PLS/HET...

# AIR FILTER CLAMPING RING

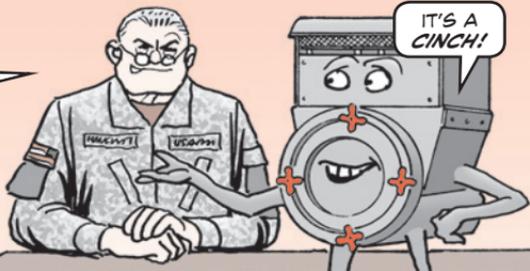
GET A NEW CLAMP RING KIT THAT MAKES SERVICING AIR FILTER ELEMENTS ON YOUR PLS AND HET A WHOLE LOT EASIER.

WITH THE NEW KIT IN PLACE, YOU *DON'T* HAVE TO REMOVE THE 12 NUTS NEEDED TO KEEP THE FILTER ELEMENT INSIDE THE AIR CLEANER HOUSING.

INSTEAD, THE NEW CLAMP RING IS POSITIONED OVER FOUR EXISTING STUDS AND HAND-TIGHTENED IN PLACE BY FOUR HAND KNOBS.

USE NSN 2940-01-547-4159 TO GET A KIT THAT'S PAINTED CARC GREEN. NSN 2940-01-547-3724 GETS A TAN KIT.

EACH KIT COMES WITH A CLAMPING RING, ANTISEIZE COMPOUND FOR THE STUD NUTS, TWO REPLACEMENT STUDS/RETAINERS AND INSTALLATION INSTRUCTIONS.
